**Item 3.****Development Application: 422-424 Cleveland Street, Surry Hills - D/2020/993**

File No.: D/2020/993

**Proposal Summary:** The application proposes alterations and additions to the Kirk building for a mixed use development including boarding house, cultural entertainment venue and café.

**Figure 1:** View from the sun drawings

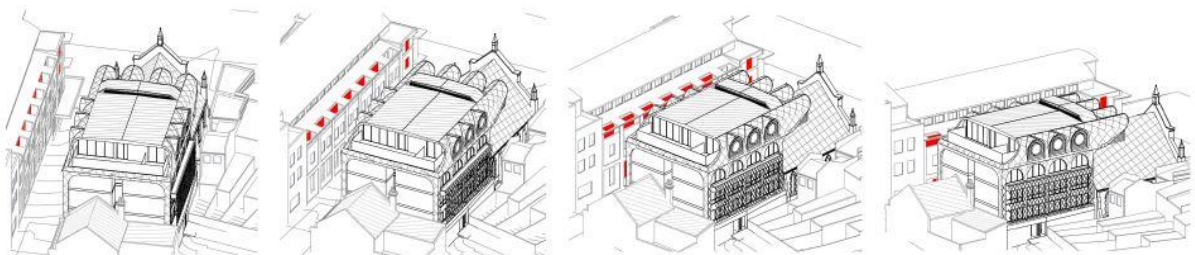
The reduced height and overall scale of the additions can now be considered acceptable, however any impacts on neighbours due to additional shadowing need to be clarified. Although there is a distinct jump in building height from High Holburn Street and Goodlet Lane to development controls along Cleveland Street the proposal has improved to include landscape and terrace to step down in scale on the north of the upper level.

The solar access to 426 Cleveland Street appears to comply with the requirements of the ADG and the City's Draft Overshadowing Documentation Guide.

The proposal will impact on apartments within the converted warehouse building to the east at 426 Cleveland Street. 14 apartments face west, 8 of the apartments currently receive 2 hours of sunlight, 6 of the apartments receive less than 2 hours of sunlight as the ground level apartments do not start receiving sunlight until after 1pm. The upper level apartments retain sunlight as they are not impacted upon until 3pm.

The lower level apartments will be impacted and will not receive sunlight. Given that any form of development other than a single storey form with a flat roof would result in overshadowing to these apartments, the overshadowing is acceptable in the circumstances given the permitted height controls for the development.

14. The shadowing impacts are illustrated in the following view from the sun drawings in Figure 1 that show time intervals of (from left to right) 12.00pm, 1.00pm, 2.00pm and 3.00pm (mid-winter). The red shaded areas on the drawings illustrate available sunlight to the principle living areas and balconies in front. The upper level apartments of 426 Cleveland Street retain DCP compliant 2 hours of solar access between 12.00pm to 2.00pm with the additional non-compliant height of the proposal.

**Figure 2:** View from the sun drawing 11.00am

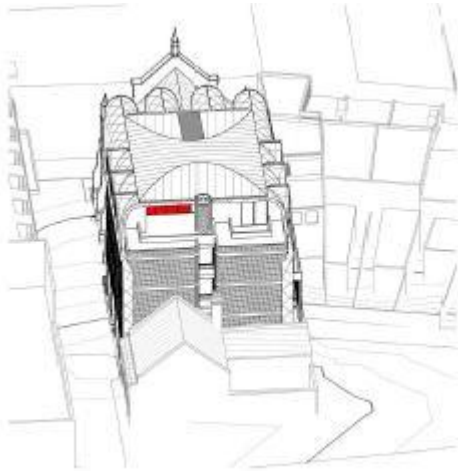
15. The overshadowing of development to the west will be impacted to 11.00am and then retain sunlight access thereafter. This is illustrated in the view of the sun diagrams above, and the additional 11.00am drawing below. They retain compliant sun access mid-winter.

Figure 3: Louvre details east façade

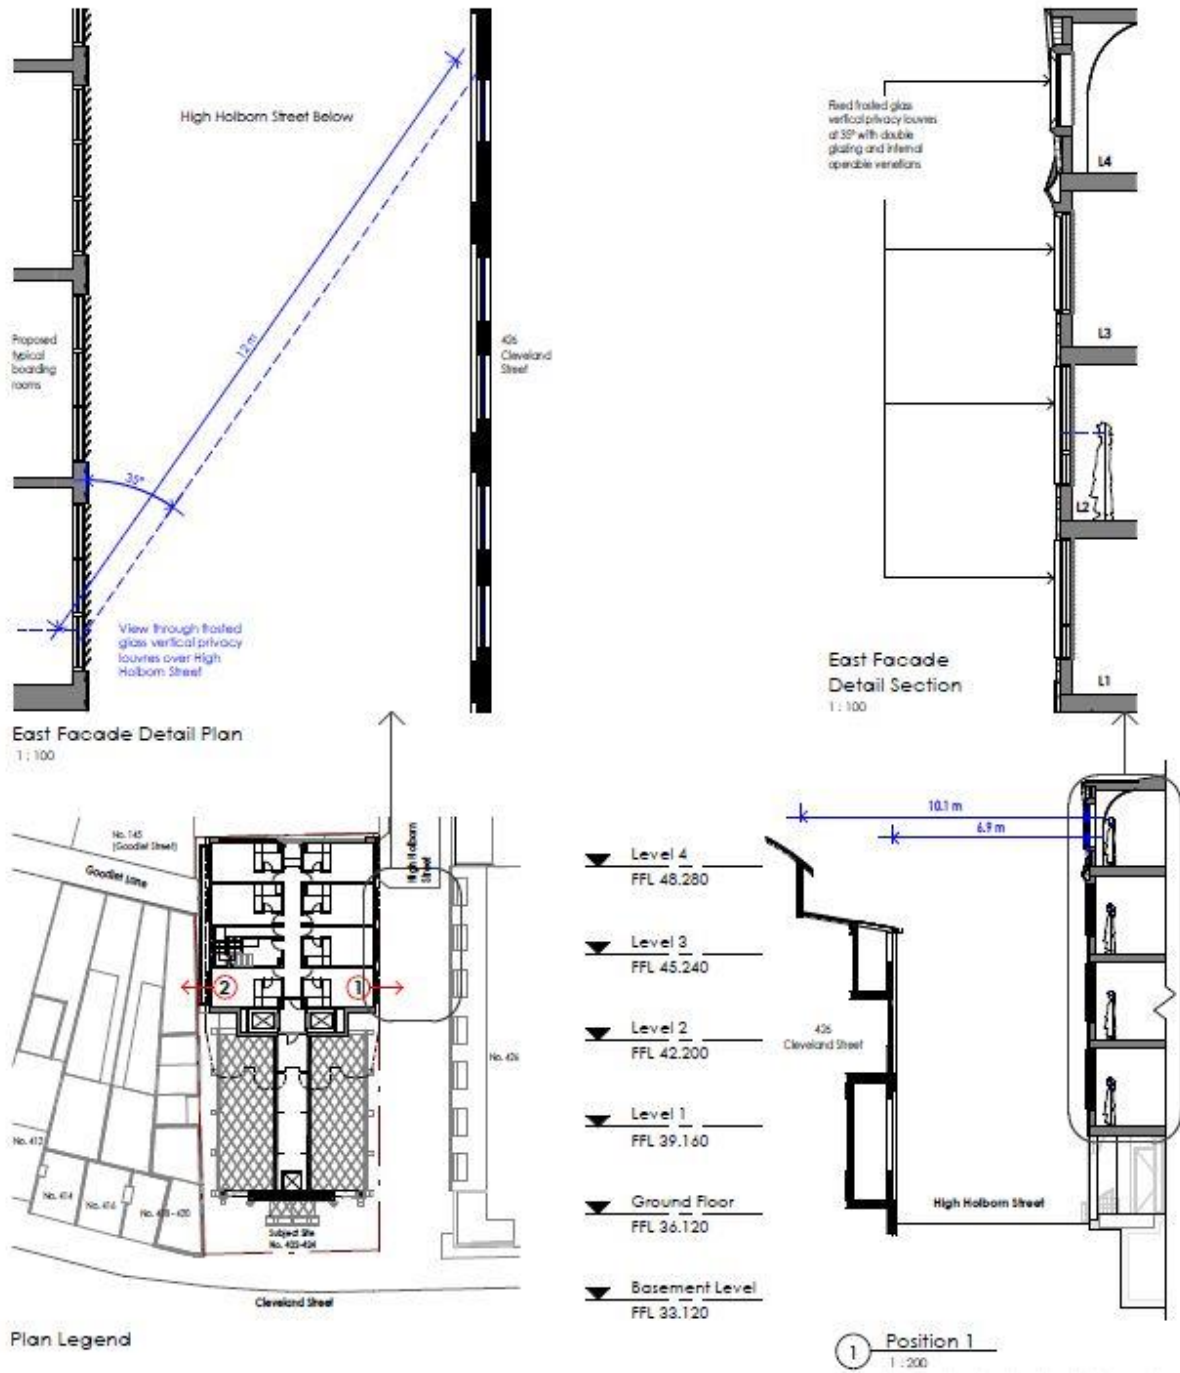
Zero setback on east boundary leads to difficulty with privacy screening and results in poor outlook from the rooms and compromised amenity. A larger scale louvre or some shaping to the wall could help direct views to the north east while providing better outlook and amenity. Visual privacy of the neighbouring properties appears to have been achieved.

- An updated design modification condition is included to require a reduced number of wider louvres as part of the updated recommended conditions of consent in Attachment C to address this DAPRS comment.
